## **LABRADOR RUN SUBDIVISION**

APPLICATION NUMBER 10 DATE June 17, 2010

REQUEST Subdivision

# DETAIL SITE PLAN

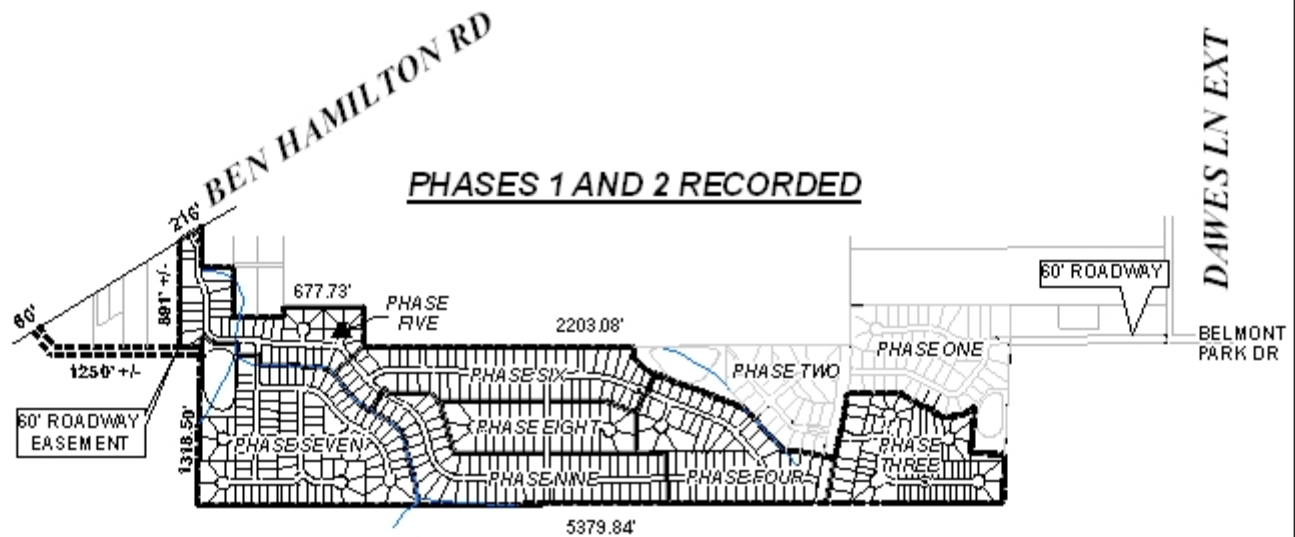
The new lots proposed for the former common area, now labeled as Phase Three, include approximately 32 lots which are less than 60-feet in width. While the lot sizes in terms of square feet meet the 7,200 square foot minimum of V.D.2 of the Subdivision Regulations, the widths of the proposed rectangular lots are only 55-feet. No justification has been provided regarding the proposed substandard lot widths.

A 60-foot wide roadway easement on the West side of the site is included in the legal description for the site and depicted on the preliminary plat. Access to the site via this easement should be denied, or the parcel in question should be included as part of the application, and the easement provided as a legitimate public right-of-way or private street.

Multiple traffic calming devices have been depicted on the preliminary plat. Mobile County Engineering Department indicates that additional traffic calming devices may be necessary due to the non-intersected straight length of some of the proposed roads.

The overall site is bounded by five land-locked parcels. Two of the smaller landlocked parcels appear to abut family-owned land that provides access to a public street, thus street stubs to these parcels would be perhaps unwarranted due to their small size and proximity to family-owned land with street frontage. Of the remaining three large land-locked parcels, the development, as currently designed appears to provide access or street stubs to only one of the larger parcels. A total of four street stubs to adjacent parcels are provided, however the previous Planning Commission approvals did require the provision of street stubs to the landlocked parcels North of Lots 20-21 and 26-27 of the proposed Phase Five, and to the parcel South of proposed Phase Seven. The subdivision should be redesigned to provide access to all three larger land-locked parcels abutting the site, as previously required by the Planning Commission.

Three detention areas are depicted on the overall preliminary plat. Two of the detention areas appear to either have frontage on a proposed street, or access from a street via a greenspace common area. The Eastern most detention area does not appear to be accessible via an easement or common area, however, review of the recorded plat for Phase One shows that it does, in fact, have frontage. Similar errors have been noted on the depicted versus the recorded Phase Two as well. Thus Phases One and Two are inaccurately depicted on the overall plat.

It should also be noted that there are several areas that are unaccounted for in terms of common area or development (near Lot 23 in Phase Three, near Lot 7 in Phase Five, near Lot 390 in Phase Seven, and near Lot 189 in Phase Nine). The plat should be revised to fully account for and label all land included as part of the development.

The plat for the Duncan Subdivision, from which a lot will be used for the proposed development, depicts a drainage easement that is not reflected on the preliminary plat for this application. The preliminary plat should be revised to depict this easement, or an application should be made to vacate the easement.

It appears that each lot meets the minimum 7,200 square feet requirements for developments with access to public water and sewer. Due to the size of the development, it is requested that the applicant revise the preliminary plat to provide the size of each lot in square feet on the plat, either as a table or as a label for each individual lot. Each phase should show the lot size in square feet on any recorded plat.

The 25-foot minimum building setback line, required in Section V.D.9., is not shown for the subdivision, but would be required on the final plat for each phase, if approved.

Greenspaces and detention areas are depicted on the preliminary plat. All common areas, whether greenspaces, detention areas, or other common areas, should be labeled as such, and a note should be placed on the final plat, if approved, stating that maintenance of all common areas shall be the responsibility of the subdivision's property owners.

- 1) Provision of a Traffic Impact Study for the overall 490 unit development;
- 2) Provision of justification for the proposed Phase Three lots that will be less than 60-feet in width;

- 3) Correction of the legal description as well as the acreage information to ensure that the entirety of the development is accurately described;
- 4) Revision of the plat to ensure that cul-de-sac rights-of-way and pavement diameters for Phases Three and higher comply with Sections V.B.14. (120-foot right-of-way diameter) and V.B.15. (96-foot pavement diameter) of the Subdivision Regulations;

- 5) Revision of the plat to accurately depict the recorded layout of Phases One and Two;
- 6) Revision of the plat to depict provision of street-stubs to the land-locked parcel North of proposed lots 20-21 and 26-27 in Phase Five, and the land-locked parcel South of Phase Seven, in compliance with Section V.B.1. of the Subdivision Regulations;

- 7) Revision of the plat to identify of all portions of the site to fully account for all acreage and the manner of site development (near Lot 23 in Phase Three, near Lot 7 in Phase Five, near Lot 390 in Phase Seven, and near Lot 189 in Phase Nine);

- 8) Revision of the plat to depict any existing drainage easements associated with previous subdivisions (Lot 1, Duncan Subdivision), or submission of a vacation request for the easements;

- 9) Revision of the plat to identify the size of all lots in square feet, either via a table on the plat, or by the labeling of each lot, to ensure that each lot meets the minimum lot size identified in Section V.D.2. of the Subdivision Regulations;

- 10) Depiction of the 25-foot minimum building setback line, in conformance with Section V.D.9. of the Subdivision Regulations;
- 11) Identification and labeling of all common areas, including greenspaces, road medians, and detention areas, and placement of a note on the plat stating that maintenance of all common areas shall be the responsibility of the subdivision's property owners;

- 12) Placement of a note on the plat stating that access to the 60-foot roadway easement on the West side of site is denied;
- 13) Placement of a note on the plat stating that approval of all applicable Federal, state and local agencies is required for endangered, threatened or otherwise protected species, prior to the issuance of any permits or land disturbance activities;
